CREATE Project P-1  
Railroad Improvement Project at 63<sup>rd</sup> and State Streets  
Job No. P-30-006-04  
Cook County  
Chicago, Illinois

**PROPOSED VIADUCT CLOSURE REPORT**  
**66<sup>th</sup> AND 60<sup>th</sup> STREETS AT THE**  
**METRA ROCK ISLAND DISTRICT LINE**

Prepared for:  
Illinois Department of Transportation  
Bureau of Railroads

May 10, 2006

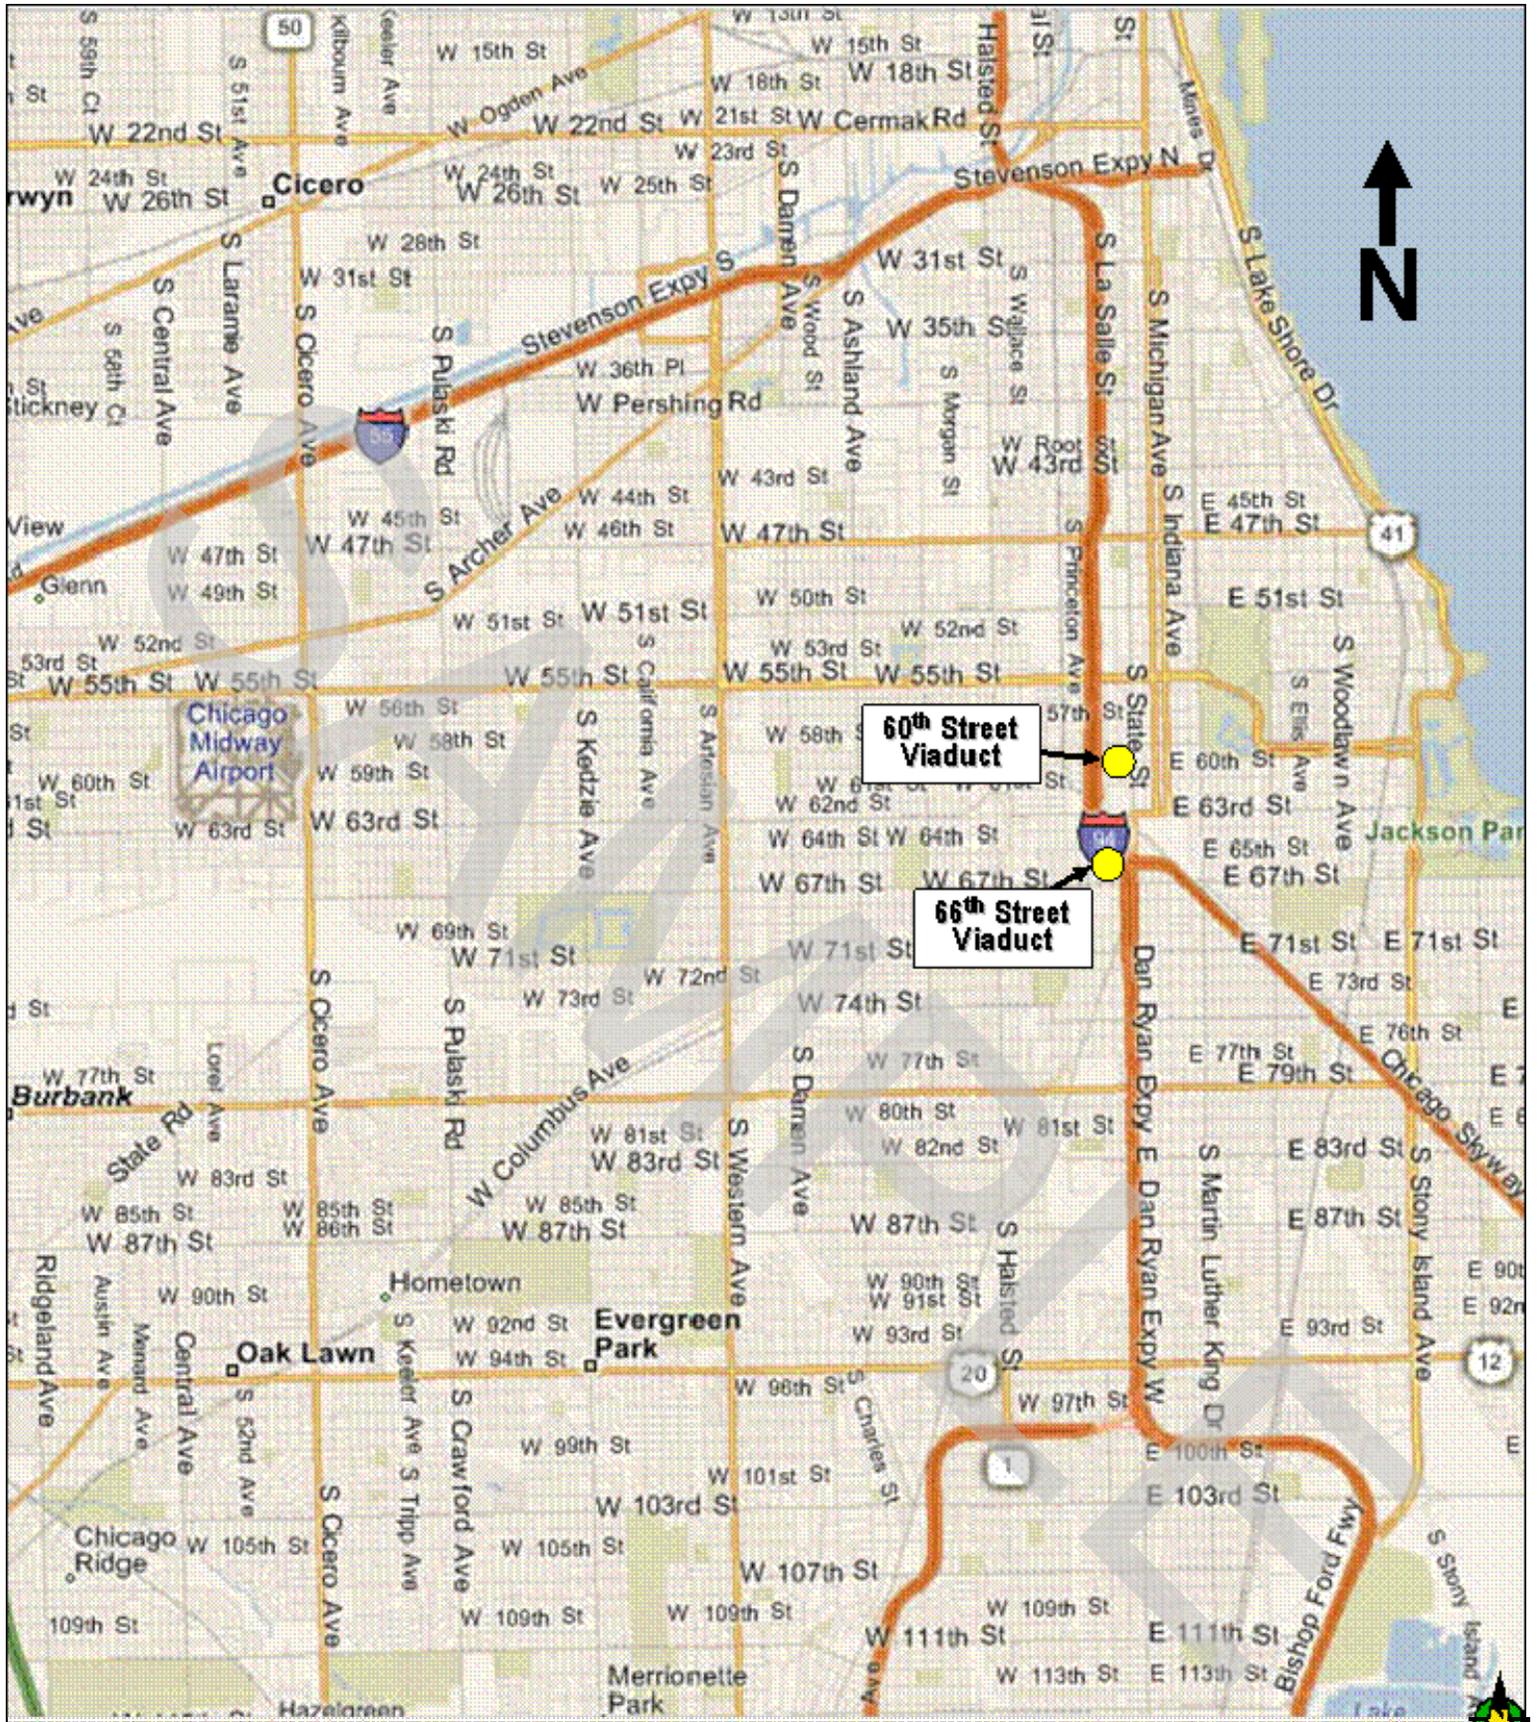
4. Page 1, inset – Add “Perry Ave.” label.

***Response:*** *Concur.*

**FIGURE 6**

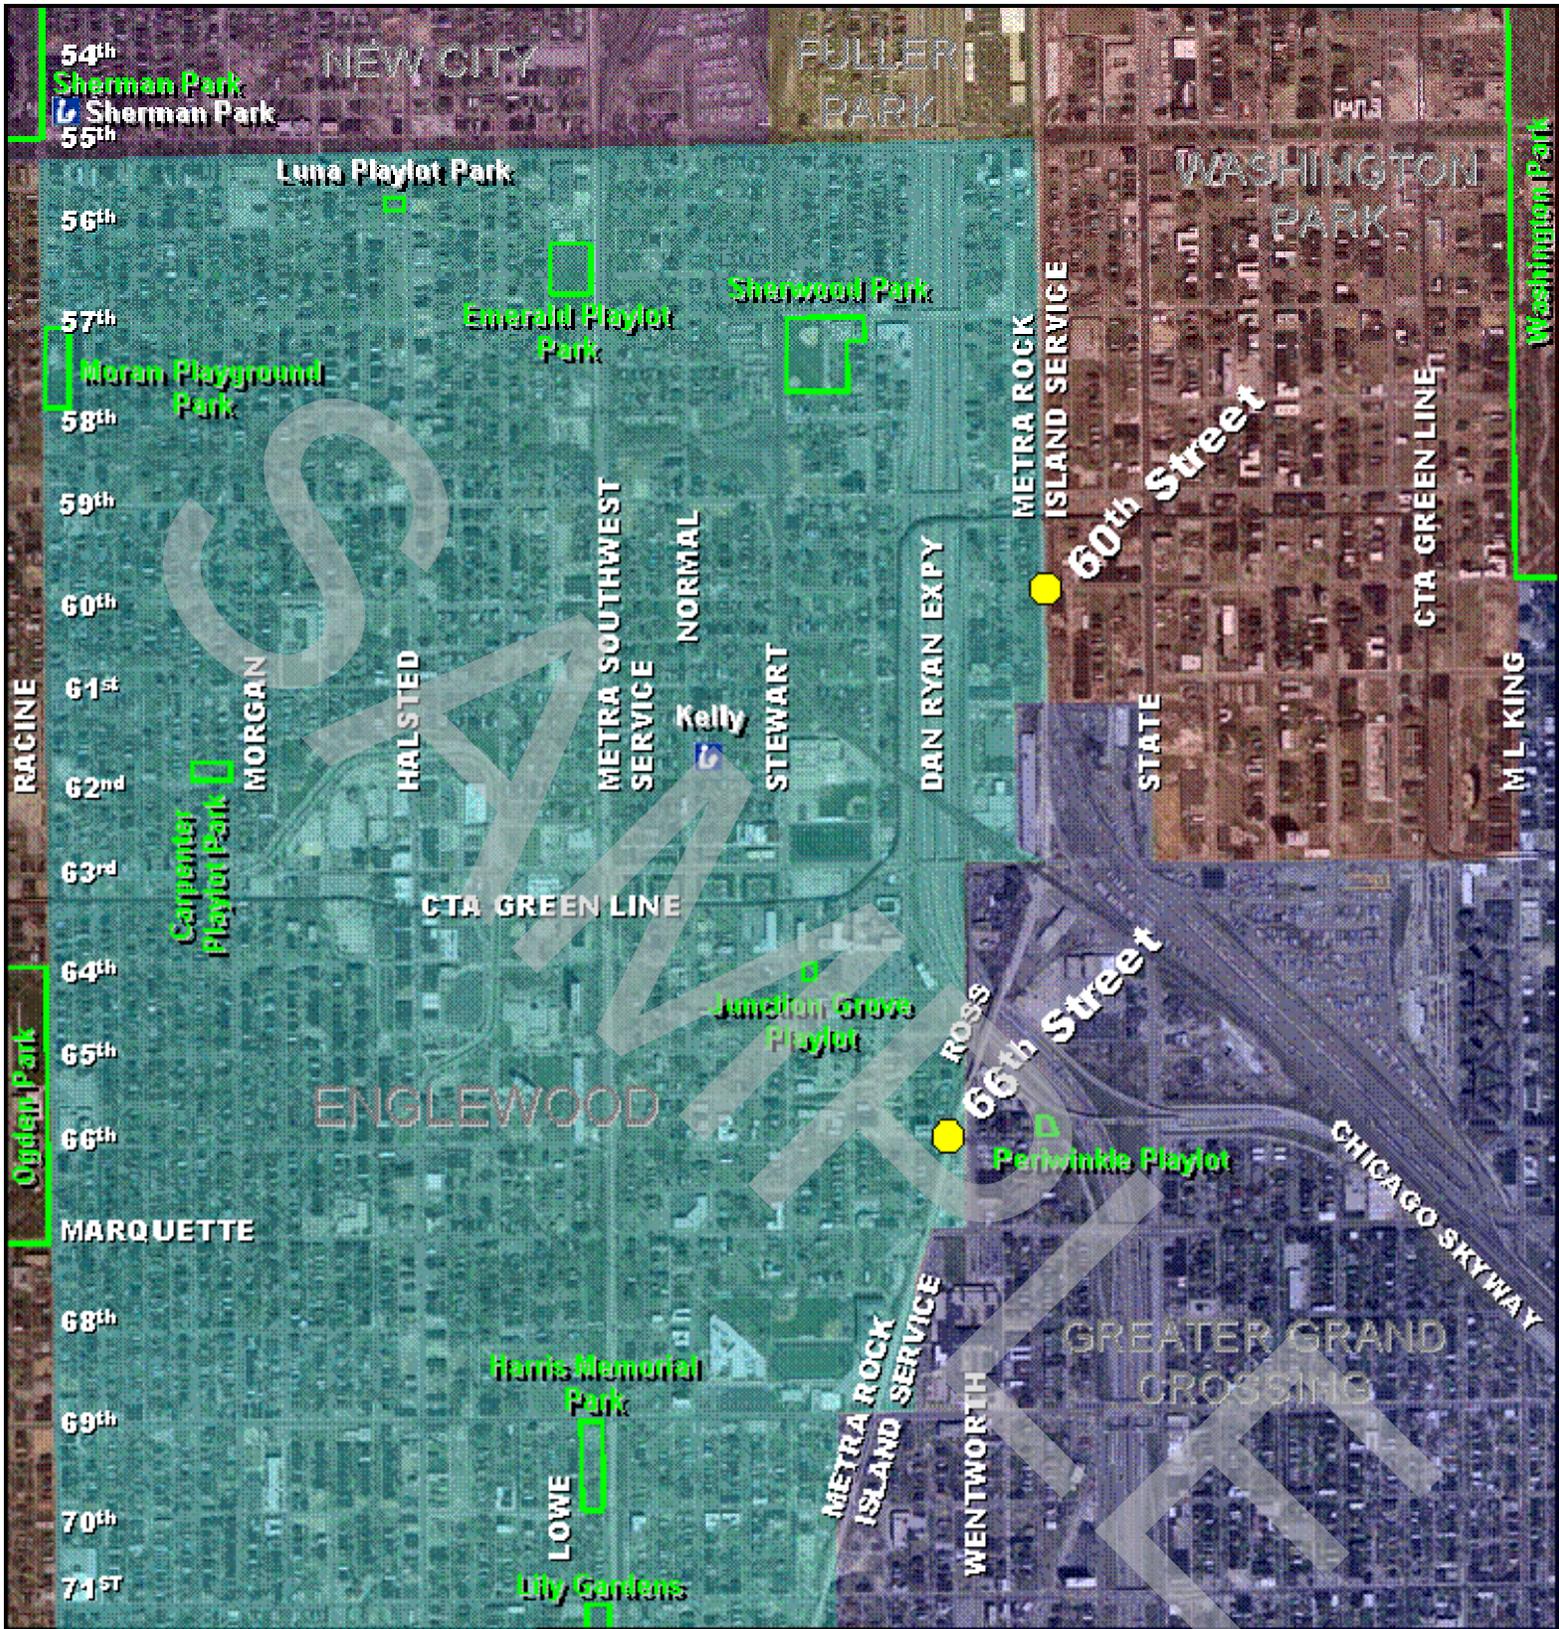
2. Page 19, Chicago Police Department, sentence beginning with "Figure 6..." This sentence states that no police stations are identified on Figure 6. Figure 6 does show 1 police station.

**Response:** *The station shown on Figure 6 is for the 7<sup>th</sup> District. This has now been identified on the figure and clarified in the text.*

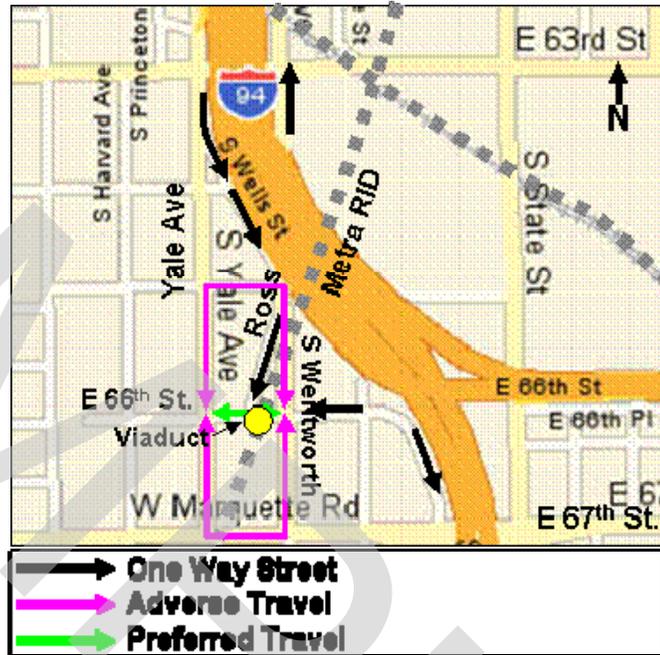
5. Page 14, inset – Add “Yale Ave.” label.

***Response:*** *Concur.*

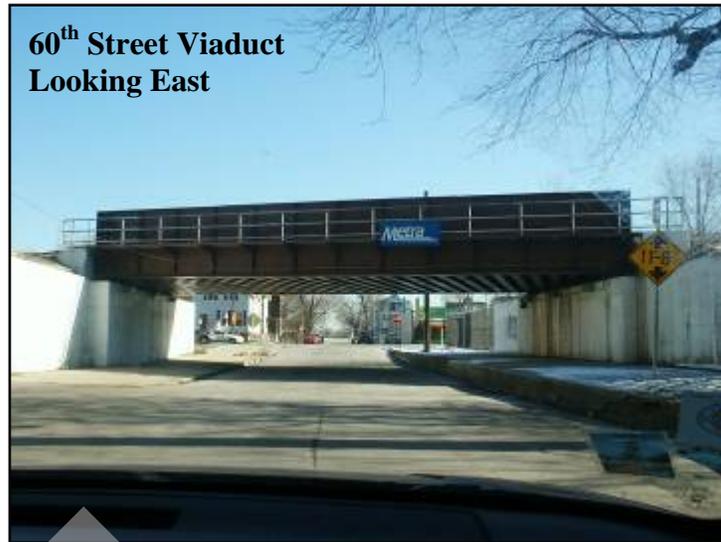
8. Page 17, inset – Add “State St.” and “Indiana Ave.” labels.

***Response:*** *Concur.*
